# KENWOOD

ASB-1058

## Service Bulletin

**Subject:** TM-455A/E Change in Pin Diode  
2006

**TX-RX Unit (X57-4510-00 C/5)**

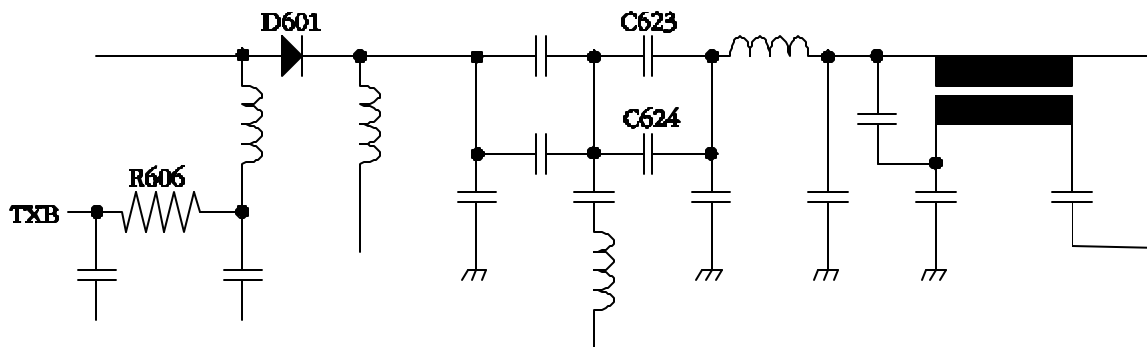
Some early versions of the TM-455A/E have been discovered with a bad solder connection at the final module pin diode, D601. If the impedance of this device is too low, the power consumption for this device goes up. This increased power consumption might cause excessive heating of the solder connections, and may result in a failure of the connection(s) after long FM transmissions.

On the TX/RX unit replace diode D601 with a UM9401, change R606 to 100 ohms, change C623 to 5 pF, and C624 to 12 pf. After replacing these parts, readjust the NULL and Protection circuit using the procedures provided in the Service Manual.

Qty	Description	Part No.	Circuit Description
1	Pin diode	UM9401	D601
1	100 ohm chip resistor	RS14DB3A101J	R606
1	5 pF chip capacitor	CM73F2H050D	C623
1	6 pF chip capacitor	CM73F2H060D	C624
